To: Alison C. Steinfeld, Planning Director
Town of Brookline Planning Department

From: James. D. Fitzgerald, P.E., LEED AP

Date: October 18, 2016

Subject: 420 Harvard Street ó Responses to Traffic Peer Review

Figure 1: Eastbound Fuller Street Sight Distance of 418' to driveway.

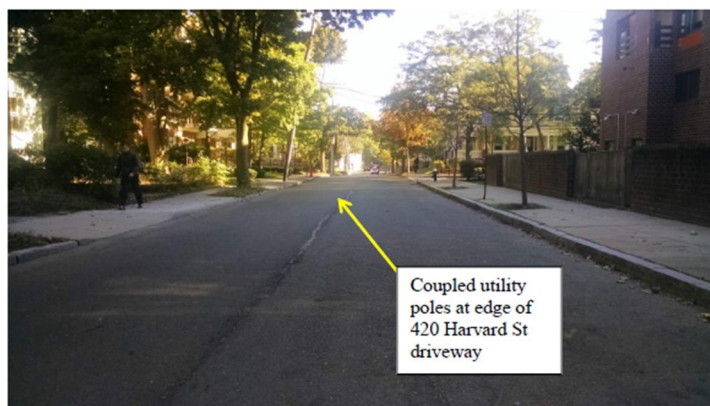
EPG's Original Comment: Sight distance from the proposed driveway will be limited by an existing 7 foot tall wooden fence along the southwestern property line that extends to the back of sidewalk. Due to the fence obstruction, sight distance for a vehicle stopped behind the sidewalk without protruding into the sidewalk is estimated at only 150 feet, which does not meet the 200 foot sight distance requirement for 30 mph.

VAI's Response: *The 200 foot sight distance requirement for 30 mph referenced above is for Stopping Sight Distance (SSD), which measures the distance between the major road driver's eye at a height of 3.5 feet and an obstruction in the road, representative of the height of automobile headlights and taillights. A vehicle traveling at 30 mph requires a certain distance to stop safely, while a vehicle traveling faster or slower requires more or less distance,*

Another set of measurements was conducted at the request of the Peer Reviewer. This is the distance between a vehicle traveling eastbound on Fuller Street and an object representing a vehicle located at the back of the sidewalk, waiting to pull out from the driveway. This distance is shown below in Figure 1.

As shown in Figure 1 and measured in the field, a distance of 418 feet is available for motorists traveling eastbound on Fuller Street. This exceeds the SSD requirements identified by AASHTO for this criterion indicating safe sight distance is available. In addition, approximately 404 feet of sight distance is available from the proposed driveway location at the back of the sidewalk looking west up Fuller Street. This is shown in Figure 2.

The above recent supplemental data shows a substantially slower 85th percentile travel speed of 21 to 23 mph along Fuller Street than the originally assumed conservative 30 mph. As a result, it appears that Stopping Sight Distance (SSD) is adequate. As explained above, SSD is the distance that the Fuller Street vehicle needs to safely stop before colliding with an obstruction in its path such as a vehicle exiting the site driveway. It is the minimum sight distance requirement and is being met.

Ideally, the driver exiting the site driveway would have additional visibility of oncoming Fuller Street eastbound traffic while stopped behind the sidewalk in order to reduce the potential for the exiting vehicle to protrude into the sidewalk to see oncoming traffic. (VAIø Figure 2 above shows line-of-sight of an exiting vehicle stopped on the sidewalk to gain clear sight of oncoming traffic.) The adjacent fence is not solid and the space between boards affords drivers stopped behind the sidewalk some small level of interrupted visibility. However, it is likely that some vehicles will stop in the sidewalk to get improved line-of-sight around the existing fence given the urban environment. Although alterations to the adjacent fence would be preferred, speed counts indicate a slow travel speed along Fuller Street and the minimum SSD requirements for Fuller Street traffic are met regardless.

Figure 2: Westbound Sight Distance of 404' from driveway

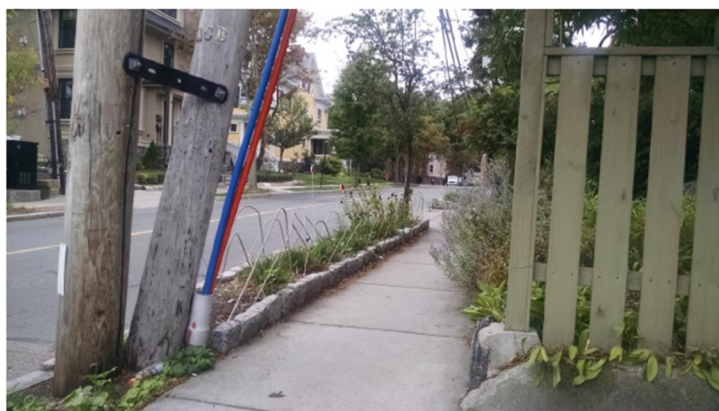
It should be noted that the utility poles shown in Figure 2 are proposed to be relocated.
